THIS REPAIR IS APPLICABLE TO DRG. # T06080472-A1.

Robbins Engineering, Inc./Online Plus™

From:  "MICHELLE MURRAY" <mayotruss@alltel.net>
To: <mark@isaacconstruction.com>
Subject: REPAIRS FOR CATO
Attachments: [ISAAC-CATO_T06041877_\(TI-A1_\).CATO-N-A-T06080552.pdf](#)

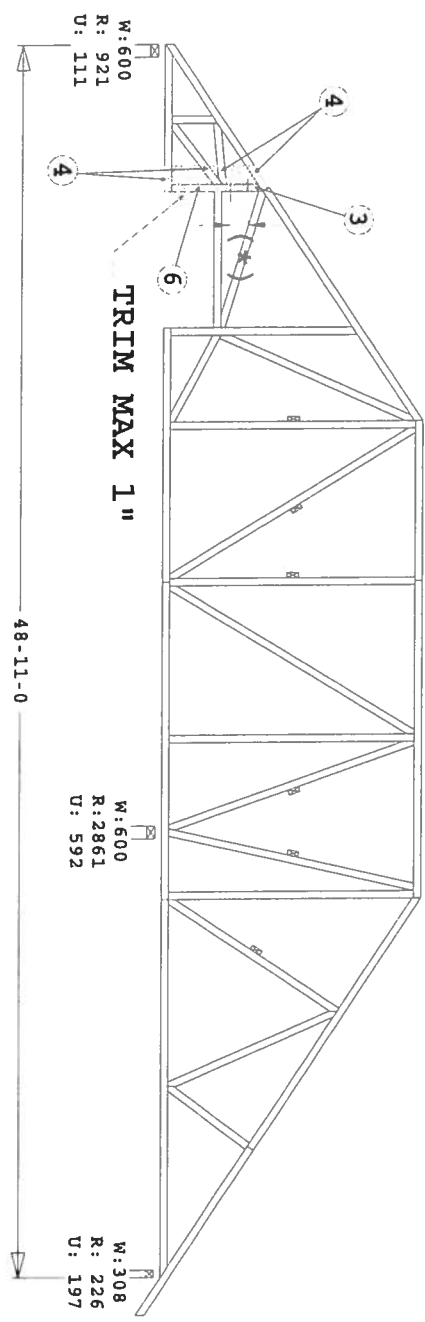
PORTION OF VERTICAL MEMBER BROKEN OUT WHERE SHOWN (*).

NEED TO TRIM THE VERTICAL MEMBER 1" OFF WHERE SHOWN DASHED.

ATTACH 2X12 SP#2 SCAB (SHADED), TO ONE FACE OF TRUSS USING CLUSTERS OF 10d COMMON NAILS.

TO UNDAMAGED PORTION OF TRUSS WHERE SHOWN CIRCLED.

THIS REPAIR IS APPLICABLE TO DRG. # T06080472-A3.
FOR ALL LUMBER, PLATES, ETC.; NOT SHOWN REFER TO ABOVE DRAWING NUMBERS.

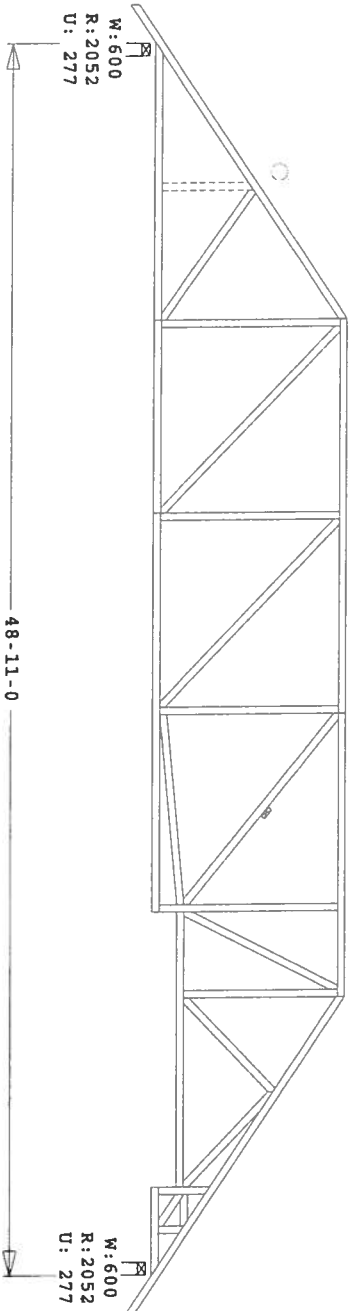
REPAIR PROBLEM: CRITICAL MEMBER BROKEN OUT WHERE SHOWN DASHED.

TOP CHORD PLATE IS INTACT AND FULLY EMBEDDED INTO DIAGONAL WEB.

NO REPAIR IS NEEDED.

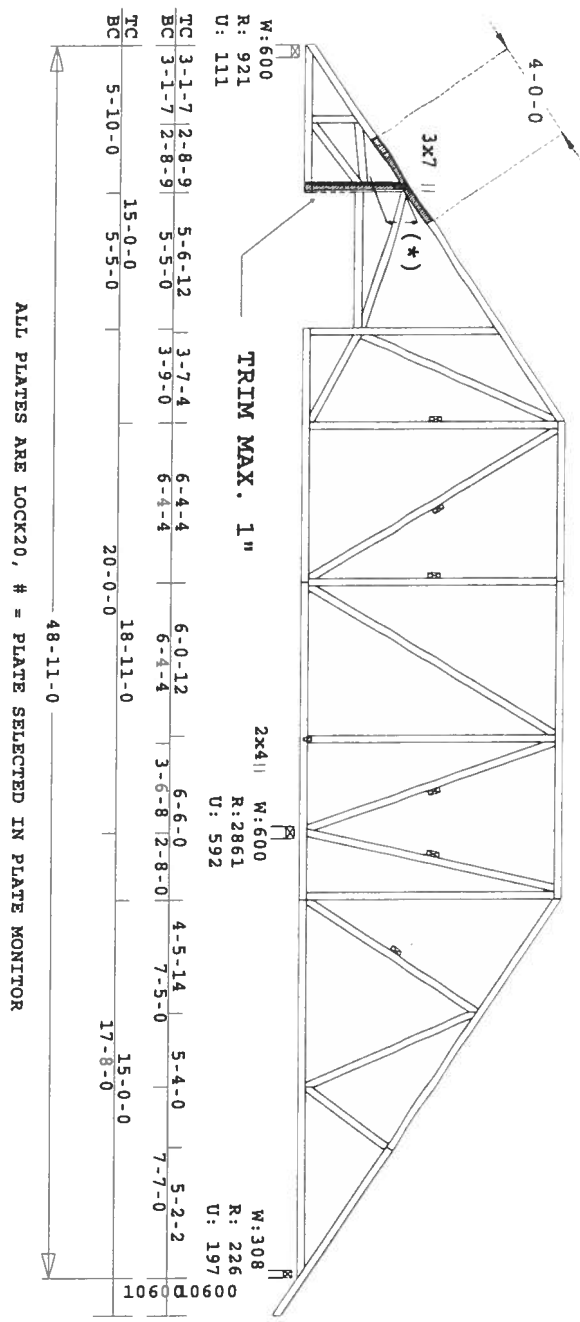
REPAIR PROBLEM:
 PORTION OF VERTICAL MEMBER BROKEN OUT WHERE SHOWN (*).
 NEED TO TRIM THE VERTICAL MEMBER 1" OFF SHOWN DASHED.

REPAIR SOLUTION:
 APPLY ALL FASTENERS SO AS TO AVOID DAMAGING OF LUMBER AND LOOSENING OF PLATES AT JOINTS.
 FABRICATE FINGER-SCAB (SHADED) USING LUMBER AND PLATES SPECIFIED AND ATTACH TO ONE FACE OF
 TRUSSES USING 2 ROWS OF 10d COMMON NAILS AT 3" ON CENTER EACH ROW AND STAGGERED INTO UNDAIMAGED
 LUMBER.

NGER SCAB MEMBERS:
 CP 2x4 SP#2
 EB 2x4 SP#2
